STAFF RECOMMENDATION

NCPC File No. 6885

WEST POTOMAC PARK LEVEE SYSTEM IMPROVEMENTS

Submitted by National Park Service

1976 SOM Plan, showing view corridor from Virginia Avenue

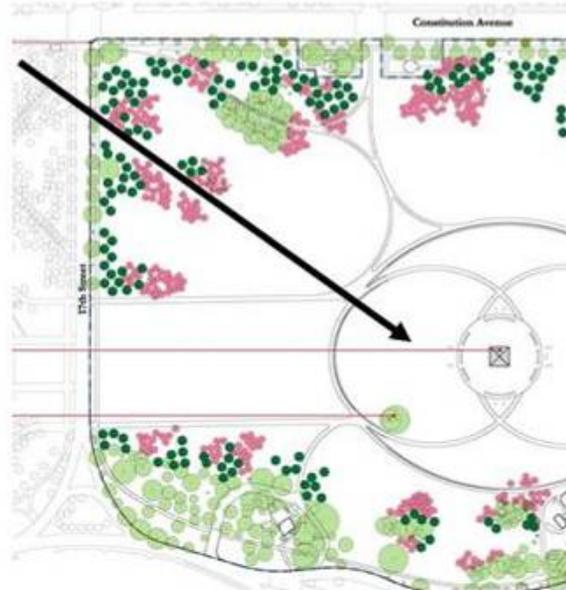
Both the plan for the National Mall by Skidmore Owings and Merrill (SOM) approved by NCPC in 1976 and the plan for the Washington Monument grounds by the Olin Partnership (Olin) approved by NCPC in 2003 use trees to frame reciprocal views between the Washington Monument and Virginia Avenue, and between the Monument Grounds and the Constitution Gardens overlook. These two plans also complement each other by creating a graceful transition between the broad, open character of the Monument Grounds and the generally forested character of Constitution Gardens. The reciprocal views between Virginia Avenue and the Monument were identified as historically significant during consultation, but the current landscaping in Constitution Gardens fails to acknowledge them. **Staff recommends that in developing a landscape plan for the disturbed area, the applicant develop a landscape plan that respects the intent of the 1976 SOM plan for Constitution Gardens and the 2003 Olin plan for the Washington Monument grounds.**

- develop a landscape plan that respects the intent of the 1976 Skidmore, Owings & Merrill plan for Constitution Gardens and the 2003 Olin Partnership plan for the Washington Monument grounds, and that minimizes encroachment on the World War II Memorial.
- strive to minimize, to the extent possible, the visual intrusion of masonry walls on the 17th Street view corridor by modulating the relationship of walls to earthen berm.

Proposal showing revised paths. Revised planting plan to be developed.

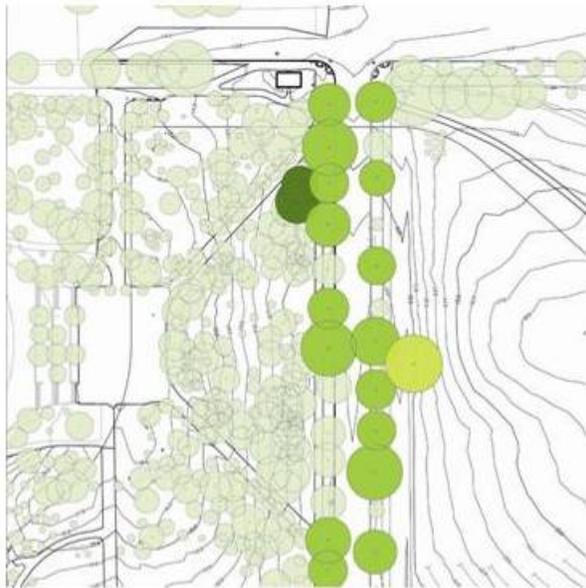
The proposal also includes modifications to the existing pathways leading to and from the Constitution Gardens Overlook site. The existing pathways are poorly aligned with each other and poorly coordinated with existing conditions such as crosswalks. Redesigning the pathways in a curvilinear pattern complements the curvilinear design of pathways on the Washington Monument grounds as well as the floodwalls themselves, while creating space around the floodwalls. But the arc of the southern walkway, to the northeast of the World War II Memorial, crowds the memorial and the Elm Walk. **Staff therefore recommends that in the revised landscape plan for Constitution Gardens, the walkways be laid out in a way that minimizes encroachment on the World War II Memorial.**
